PANEL REFERENCE	PPSHCC-335 - MA2024/00381 (PAN-482741)
LGA	Newcastle City Council
Proposal	Section 4.55(2) modification to DA2019/01169 for mixed use development, demolition of structures, erection of 14 storey mixed use including seniors living and aged care facilities - design changes to replace seniors living and aged care facilities with residential apartments
ADDRESS	124-126 Bull Street, Newcastle West (formerly known as 309 King Street, Newcastle West)
APPLICANT	GWH King Street Pty Ltd
OWNER	GWH King Street Pty Ltd
DATE OF LODGEMENT	5 November 2024
DOCUMENTS SUBMITTED FOR CONSIDERATION	<ul style="list-style-type: none"> • Attachment A: Amended Schedule of Conditions – changes shown in red • Attachment B: Amended Schedule of Conditions – clean set • Attachment C: Updated Architectural Drawings • Attachment D: Solar Analysis Assessment prepared by Gyde • Attachment E: Supplementary Sun Eye View Analysis prepared by Fender Katsalidis

This memo provides supplementary information for the proposed modification application (MA2024/00381) including associated design changes and analysis relating to Part 4A - Solar and Daylight Access of the Apartment Design Guide (ADG).

Figure 1 Extract from SK558 indicating the amendment to the air conditioning enclosure and increase in sunlight at 9am of the winter solstice

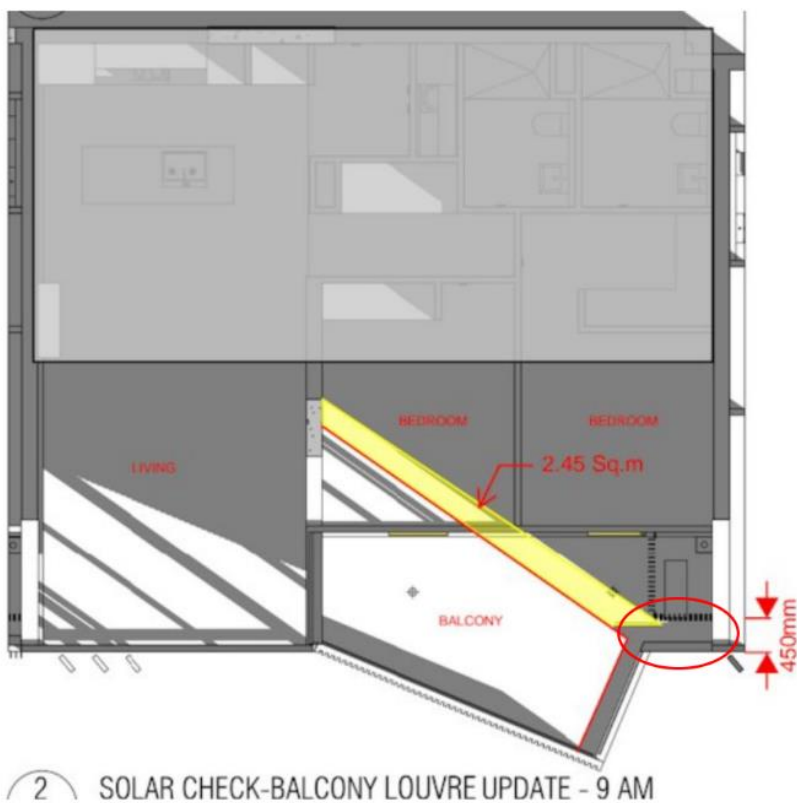
Due to the site's orientation and the current planning layout, design modifications have been incorporated to enhance solar access to the apartments on the eastern façade of Tower B. These involve reducing the width of the air conditioning plant enclosures on each balcony by 450mm. This adjustment will improve sunlight penetration into the bedrooms and living areas, as demonstrated in the half-hour solar access analysis provided in **Attachment D**. The extract from **Attachment D** demonstrates the design change to increase sunlight access, as shown in Figure 1.

Additional architectural analysis was submitted to demonstrate that reducing the width of the plant enclosure will provide adequate amenity to apartments. The applicant states a high standard of residential amenity is achieved, and solar access has been optimised, despite the numerical non-compliance with Objective 4A-1 of the ADG. In support of this, the applicant references four specific project statistics outlined on page 3 of the letter from GYDE dated 12 May 2025 at **Attachment D**.

The supplementary sun eye view analysis and assessment at **Attachment D** and **E** sufficiently address ADG Objective 4A-1 and despite the numerical non-compliance, the proposed modification demonstrates that apartments will achieve adequate amenity during the June 21 Winter Solstice. A detailed assessment of Objective 4A-1 is provided below.

a) *The width of the air conditioning enclosure (also referred to as 'balcony louvres') on the eastern balconies of Tower A and Tower B must be reduced by a minimum of 450mm, as indicated on approved drawings SK558 to SK563 prepared by Fender Katsalidis Pty Ltd.*
